Duquesne Light

SUBJECT: Beaver Valley Power Station - Unit No. 2
Docket No. 50-412
Hydrology/EPP Open Item Response

Response to Outstanding Issue 3 of the
Beaver Valley Power Station Unit No. 2
Draft Safety Evaluation Report

Response to Outstanding Issue 165 of the
Beaver Valley Power Station Unit No. 2
Draft Safety Evaluation Report

FLOW = 800 CFS.
 LOCK SILL ELEV. = 647.5 FT. M.S.L.
 TAINTER GATE SILL ELEV. = 645.0 FT. M.S.L.

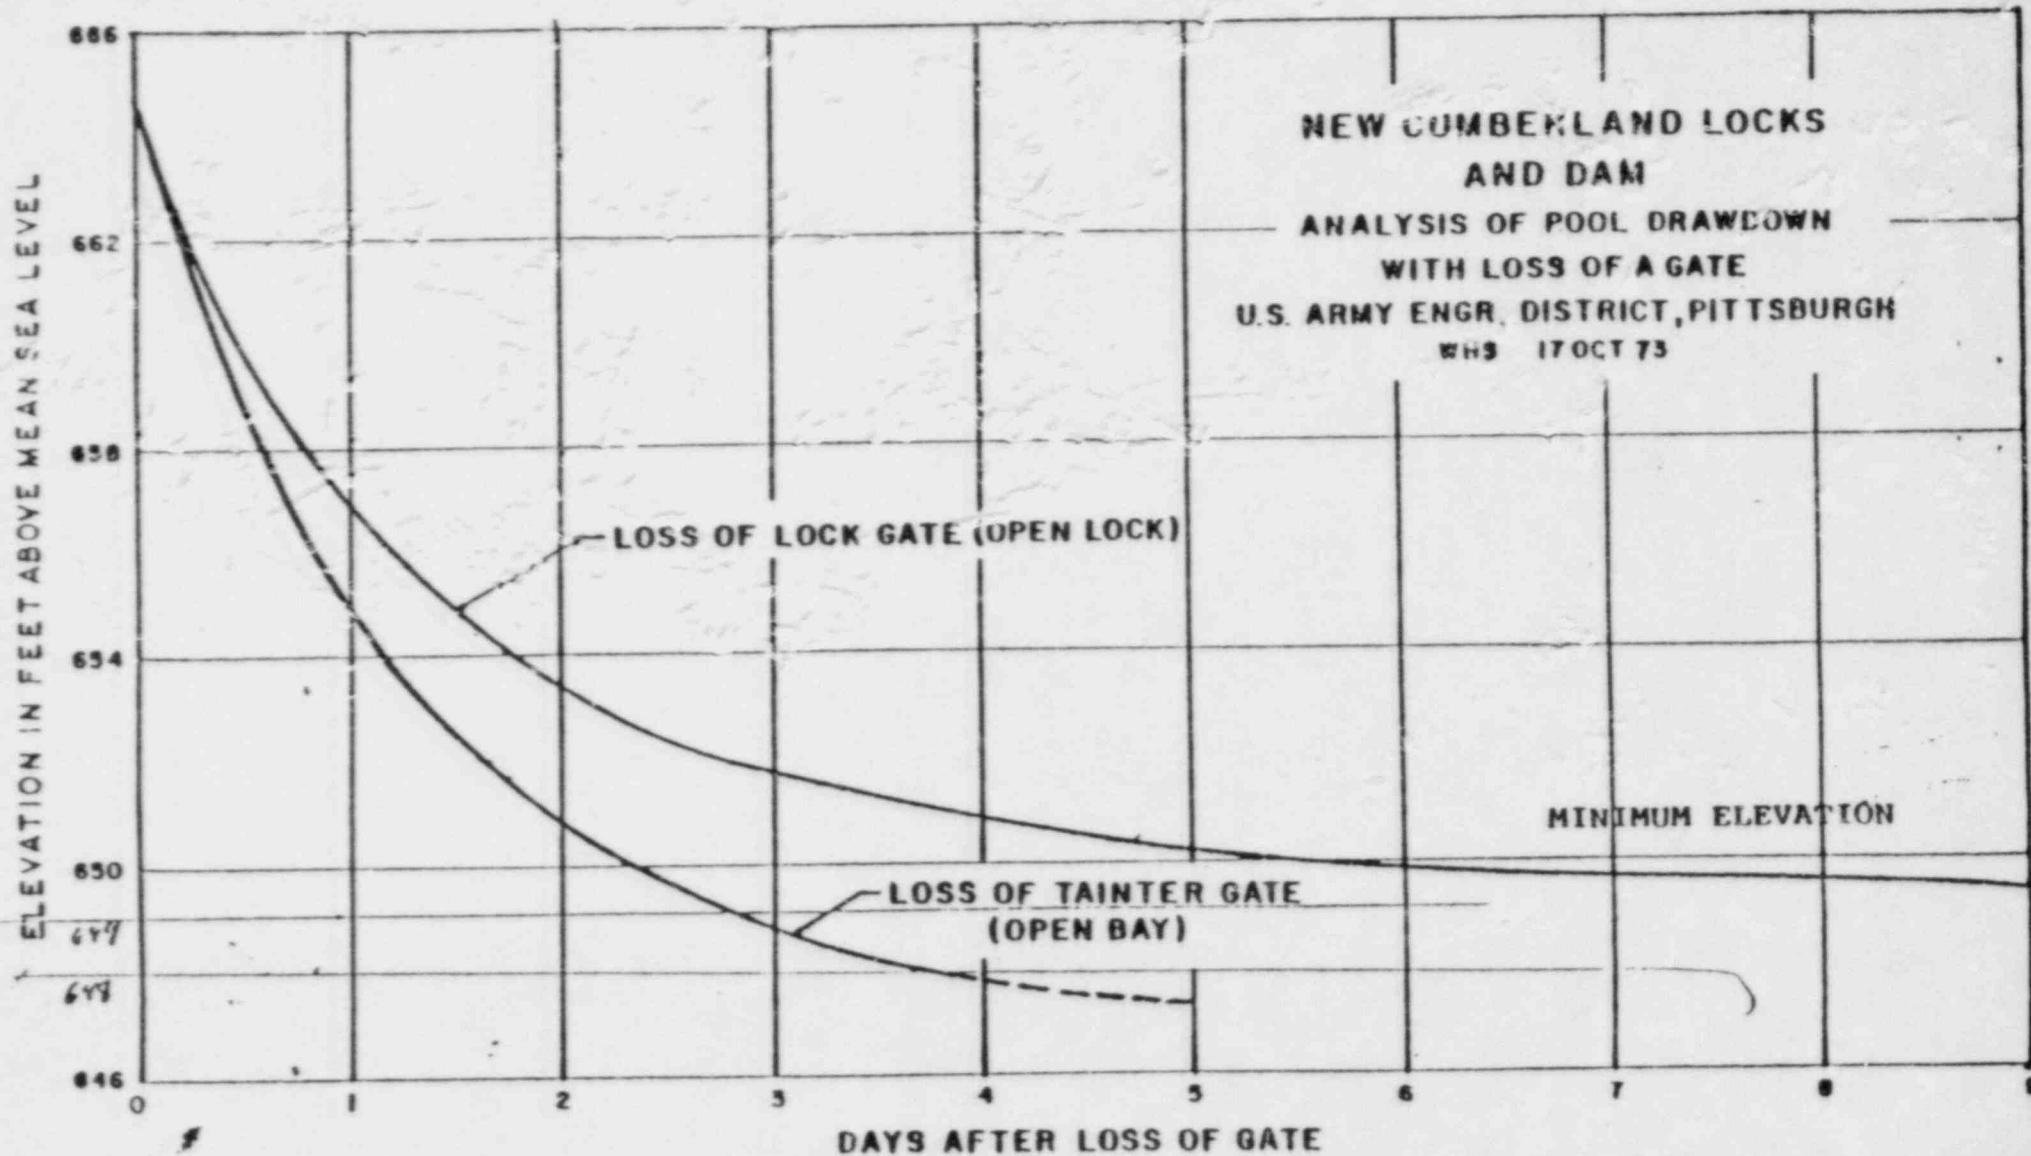
Computations were made to evaluate the loss of a tainter gate or lock gate without placing the bulkheads, although we do not consider this a reasonable possibility. Since you are interested in the rate of fall to your critical elevation of 948.0 m.s.l., we have included Plate 1 showing the pool recession for these conditions.
